**Site Address**: 14200 & 14420 Union Avenue (APN 419-08-012 & 013)

RE: Planned Development Permit (PD20-007) and Planned Development Zoning (PDC17-040) to allow the demolition of 168,460 sf of existing commercial strip mall and surface parking lot, the removal of four ordinance-sized trees, and the construction of a mixed-use project including a mixed-use building with 50,990 sf of retail/restaurant use on the ground floor and 305 multifamily residential units on the upper floors, a hotel with 229 hotel rooms and 4,610 sf of commercial use, a senior building with 125,740 square feet of assisted living commercial use and 50 senior independent living units, 25 townhouse residential units and 48 single-family homes, including 18 accessory dwelling units (ADUs), 4.0 acres of open space, 96 surface parking spaces, 1,012 underground parking spaces, and 146 garage parking spaces for a total of 1,254 parking spaces, and associated landscaping and amenities in the NCC Neighborhood Community Commercial General Plan Land Use Designation and the Camden Avenue/Hillsdale Avenue Urban Village Plan Area on an approximately 18.13-gross acre site. This project is associated with annexation file nu

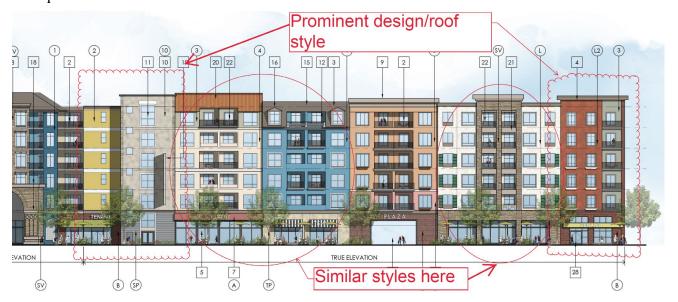
- 1. Building 1 Sheet 3.2 indicates four loading spaces for the commercial use, but the plans only call out two loading spaces (Sheet A9.0). Please review and ensure consistency.
- 2. Building 2 Two loading spaces are required for this use, but no loading spaces are labeled on Sheet A9.7. Please indicate where the loading spaces are proposed to be located.
- 3. Building 3 Sheet A9.15 calls out an Enclosed Loading Bay adjacent to the entrance to the underground parking. Please confirm the dimension of the loading bay so staff can ensure that it is sized appropriately for two loading spaces.
